BID NO. 603204-13

RON LEWIS PARK: RESTROOM, CONCESSION & STORAGE BUILDING

ADDENDUM NO. 1

C4
SHEET 4 of 4 SHEETS

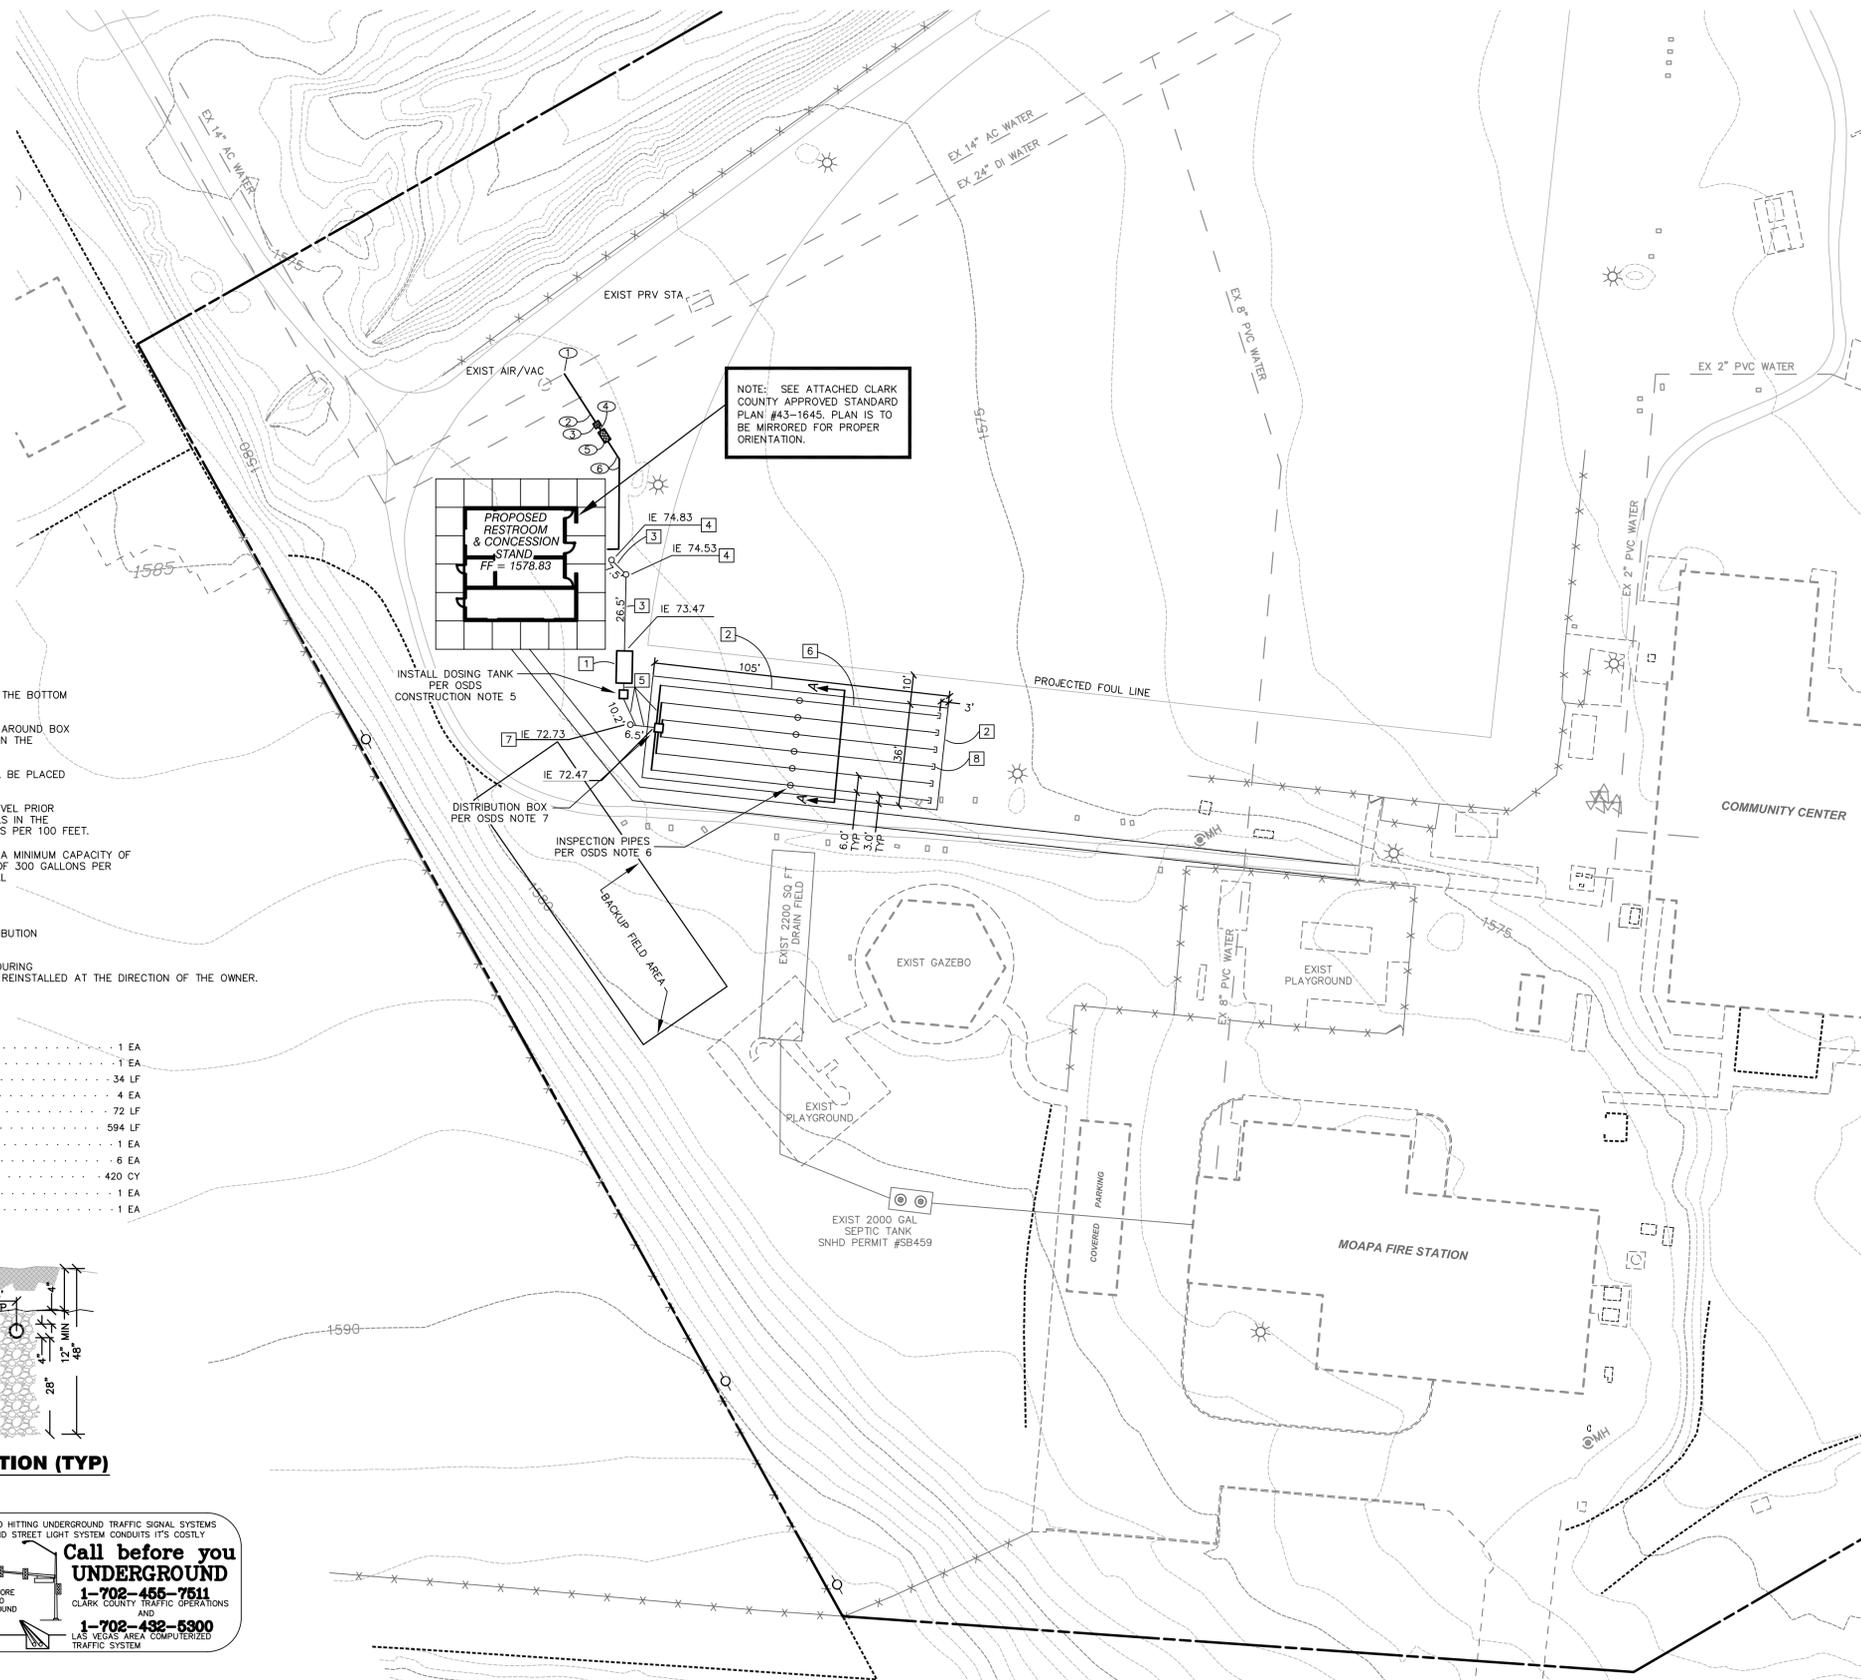
7. Sheet A-1 (Schedule)
Base bid to **EXCLUDE** the following Kitchen Equipment (schedule on A-1):
 - a. B108 (2-Door Reach-In Refrigerator)
 - b. B109 (22" Ice Dispenser)
 - c. B110 (20 LB Bagger)
8. **Delete** the original Civil Sheets # C1, C2, C3 & C4 and **Replace** with the attached revised Civil Sheets #C1, C2, C3 & C4.
 - d. Please notice the smaller size of the septic tank and the smaller size of the leach field as reflected in the attached revised Civil Sheets #C1, C2, C3 & C4.
 - e. **Do not** provide price for the Alternate location of the leach field. It is only required for NDEP plan review.
